SUBJECT: Forwards addl info re proposed license amend permitting unmonitored individuals in area surrounding Warehouse 4 for unlimited periods of time.

Re: Oconee Nuclear Station
Docket Nos. 50-269, -270, -287

Duke Power Company
Oconee Nuclear Station
Warehouse No. 4 Information

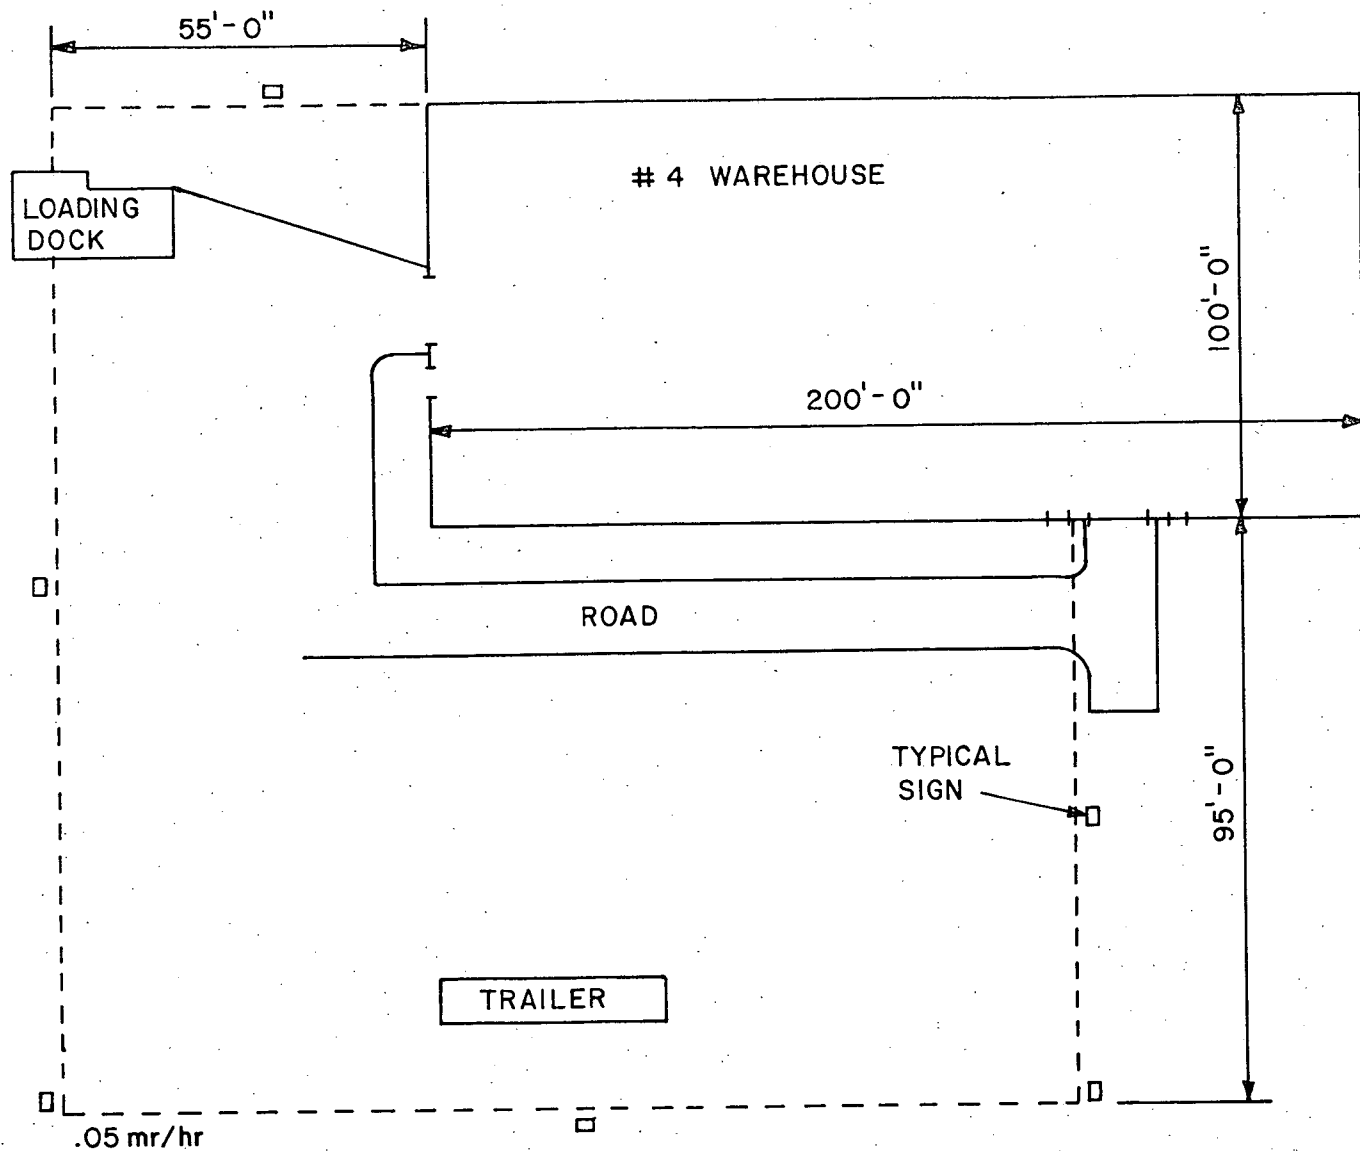
Attachment 1 provides the general location of Warehouse No. 4 with respect to the remainder of the station. The on contact dose rate on the exterior walls of Warehouse No. 4 is 0.62 to 1.2 mR/hr. The approximate 0.05 mR/hr boundary is denoted by the dotted line on Attachment 2. It is approximately 55 feet to the east of the building and 95 feet to the north.

Personnel entering the building are required to wear appropriate dosimetry, and protective clothing. Appropriate administrative measures are in effect to control access to Warehouse No. 4. Personnel within the 0.05 mR/hr boundary area are limited to occupancy times of no greater than five hours per week. This maximum allowable occupancy time is contained in appropriate administrative documents.

An 0.05 mR/hr boundary is designated around the warehouse and has signs posted to control area entry. The boundary is surveyed weekly to assure that levels remain less than 0.05 mR/hr. Contact readings are taken periodically to assure radiation levels do not exceed 2 mR/hr at the building exterior walls. These measures are included in appropriate administrative documents.
